Docket No. 50-346  
License No. NPF-3  
Serial No. 798  
March 23, 1982

I. Changes to Davis-Besse Nuclear Power Station Unit 1, Appendix A  
Technical Specifications

Figures 3.1-2a and 3.1-3a of Cycle 3 Reload Report BAW-1707 (Figures 8-5 and 8-10 of the report).

B. Reason for Change (Facility Change Request 80-268 Supplement 2).

Figure 8-5. Regulating Group Position Limits, 0 to 60 EFPD,  
 Four RC Pumps — Davis Besse 1, Cycle 3  
 (Tech Spec Figure 3.1-2a)

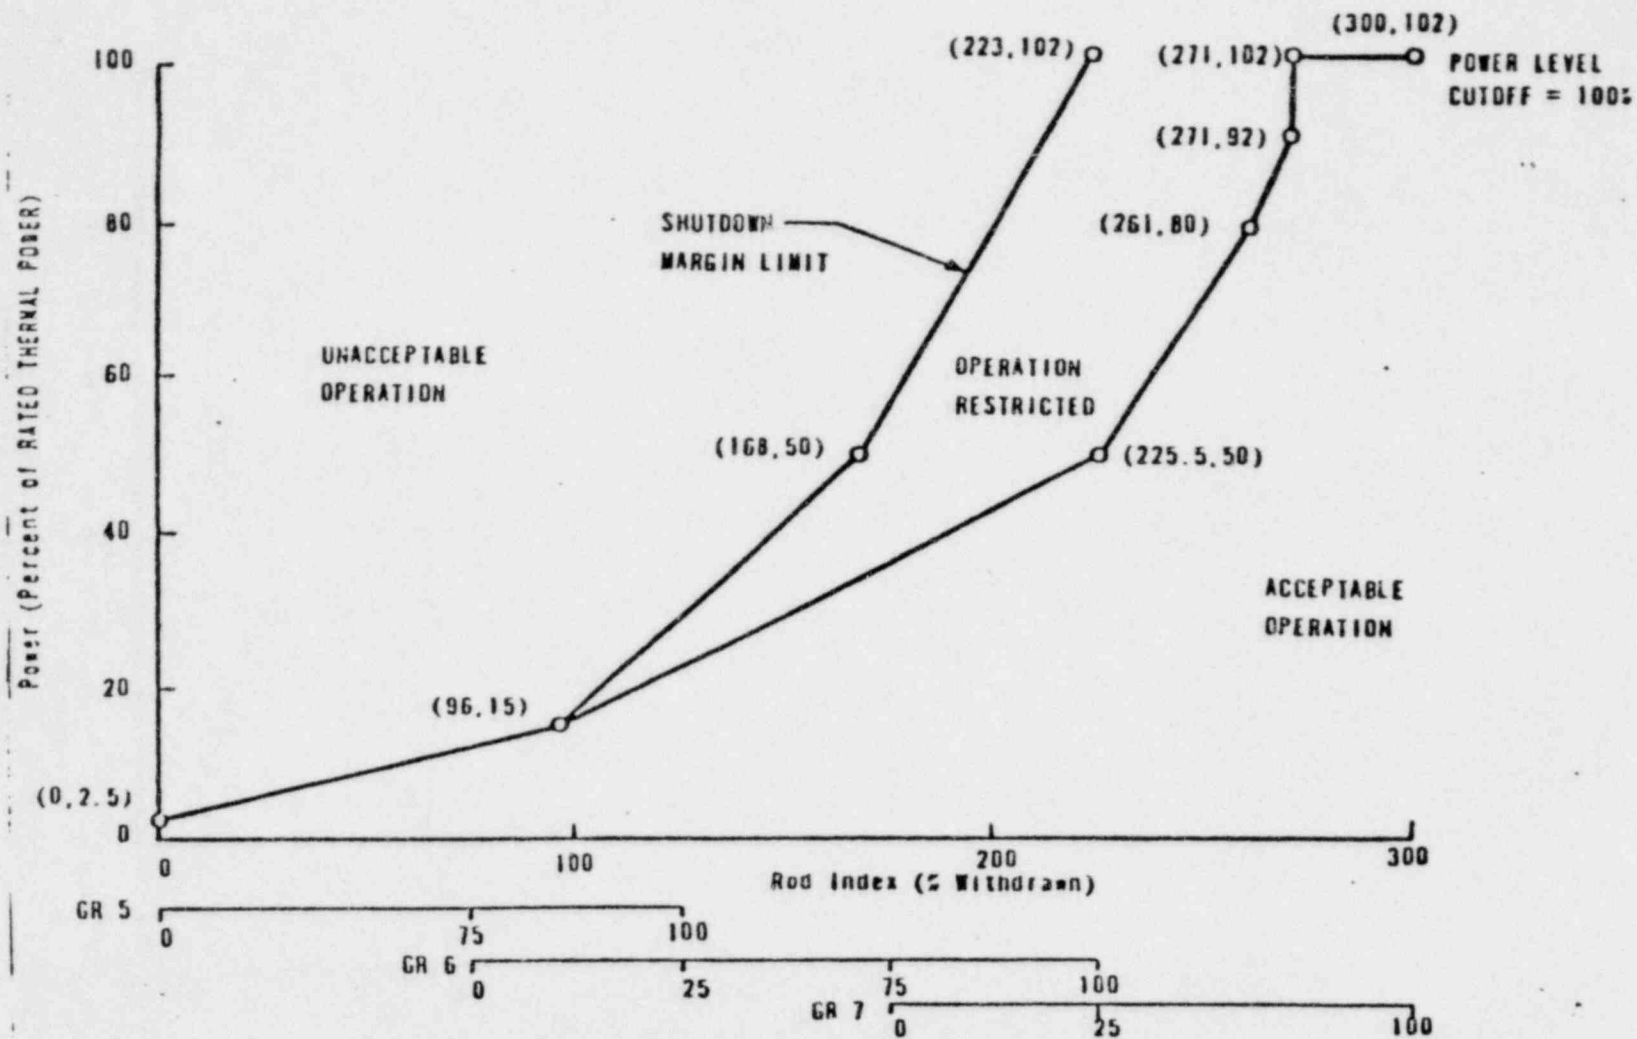
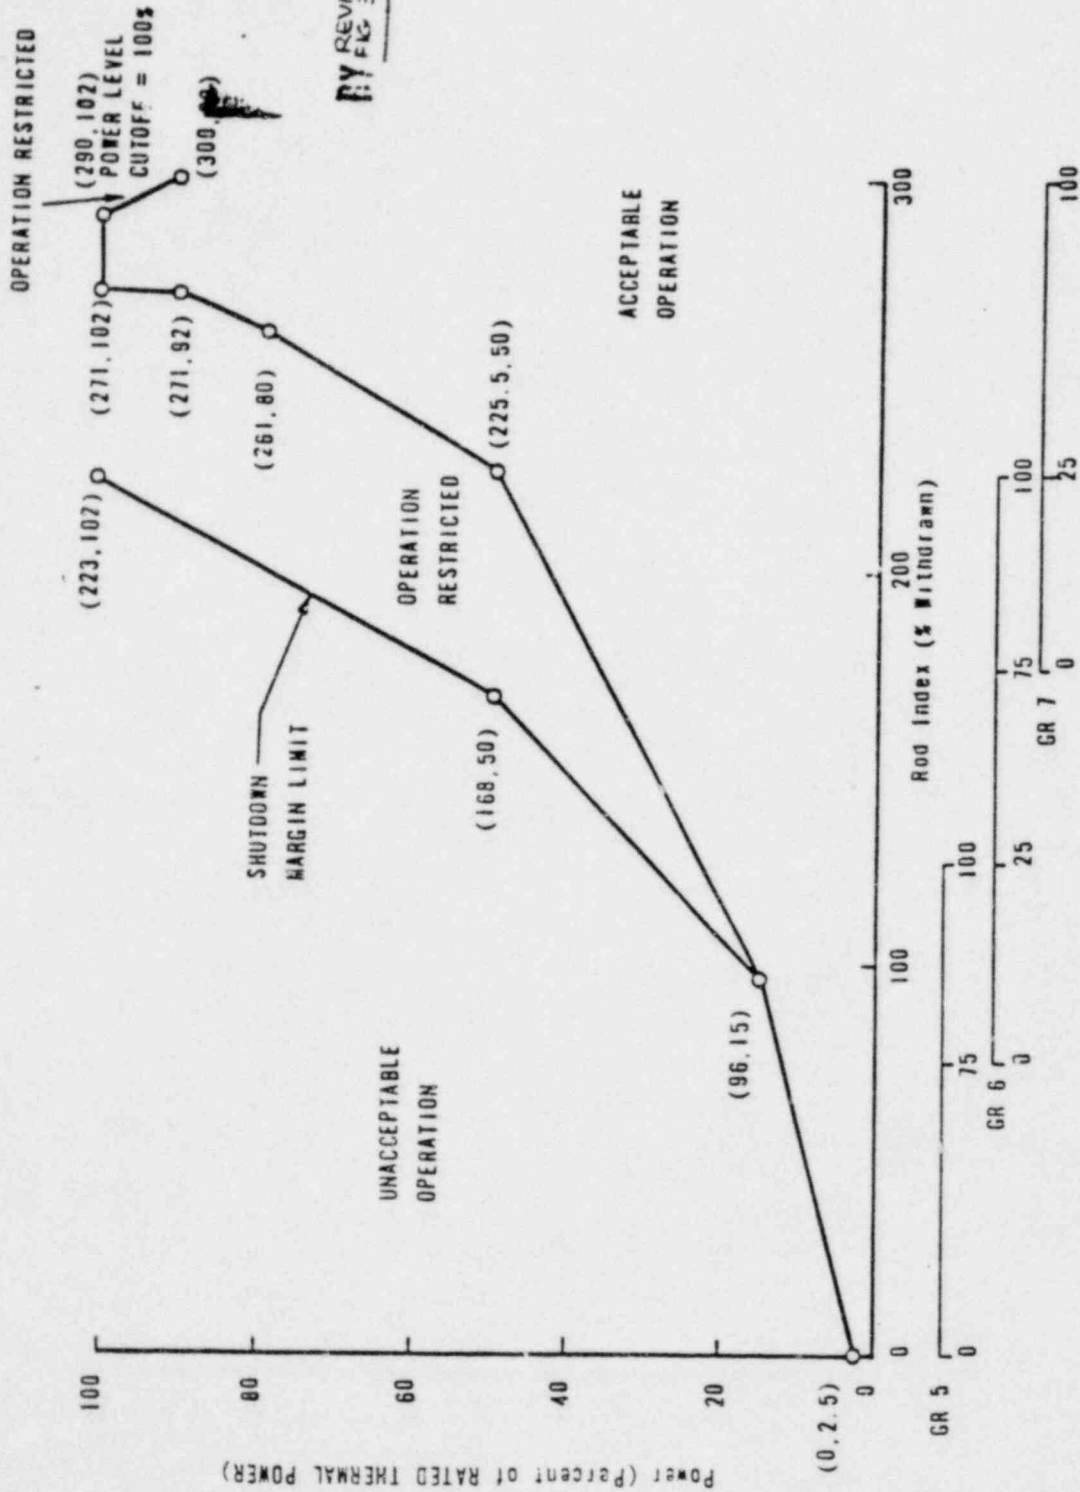
The final burnup of Cycle 2 at Davis-Besse lies within the  $306 \pm 10$  EFPD window. This results in the relaxation of the regulating rod insertion limits for the first 60 EFPD of Cycle 3.

This request provides the revised regulating rod insertion limits for four and three pump operation during the first 60 effective full power days of Cycle 3 operation. The safety function of these limits is to ensure maintenance of acceptable power distribution limits and shutdown margin. These limits also control the potential effects of a rod ejection accident.

The relaxation in the attached curves (limits) is brought about by the final burnup of Cycle 3 (296 EFPD) which lies in the  $306 \pm 10$  window of the revised Cycle 2 (complete withdrawal of axial power shaping rods and coasting down of power level towards the end of cycle) design.

**VOID**  
 BY REVISED  
 FIG 3-12a DATE 3/16/82
